SERVICE BULLETIN

#0004

SUBJECT: Placement of the ELT antenna

MODELS AFFECTED: All Sling LSA, Sling 2, Sling Taildragger & Sling 4 aircraft where an ELT is installed

EXPLODED VIEW

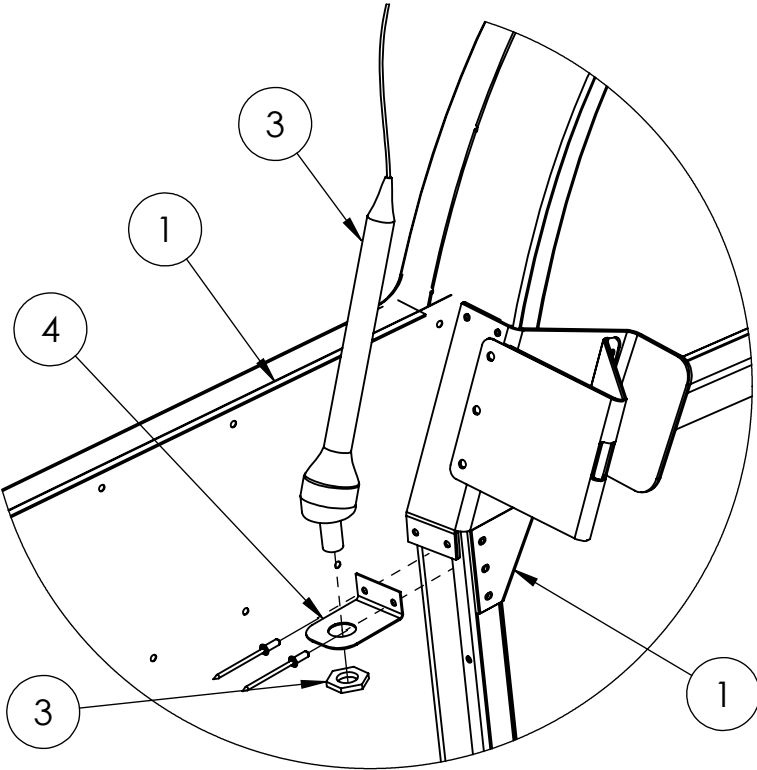
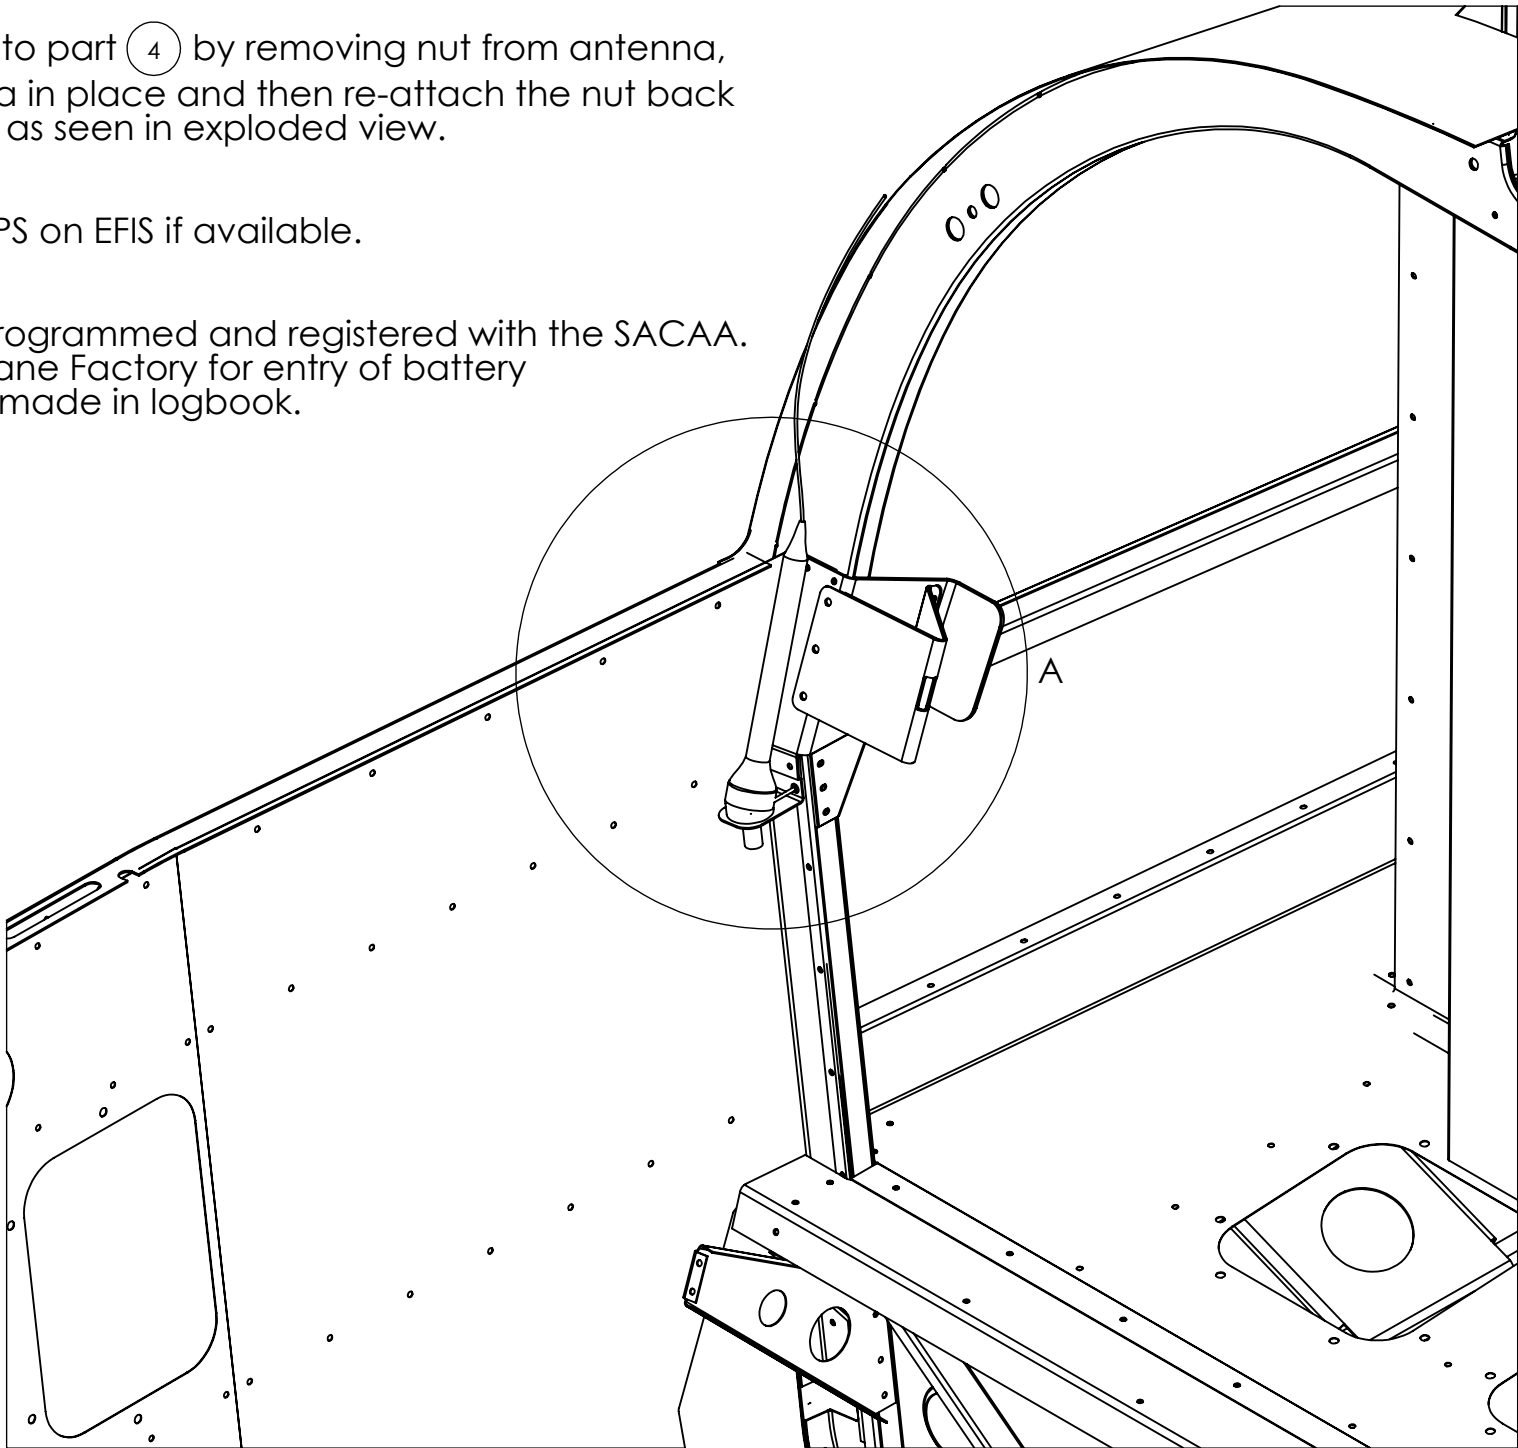
Step 1
 Whilst holding part (4) below the bottom flange of the right hand seat backrest stop (as seen in assembled view)drill first 3.3mm hole and cleco, then drill second hole.

Step 2
 Rivet part (4) with two 3.2 x 8mm Aluminium Domed Rivets into the holes drilled in step 1.

Step 3
 Connect part (3) to part (4) by removing nut from antenna, place the antenna in place and then re-attach the nut back onto the antenna as seen in exploded view.

ASSEMBLED VIEW
 (DETAIL A)

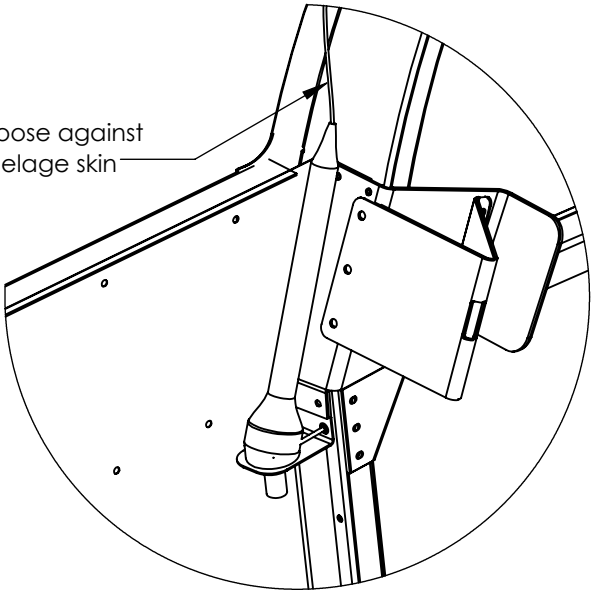
Note:
 The antenna will lie loose against the inside of the fuselage skin
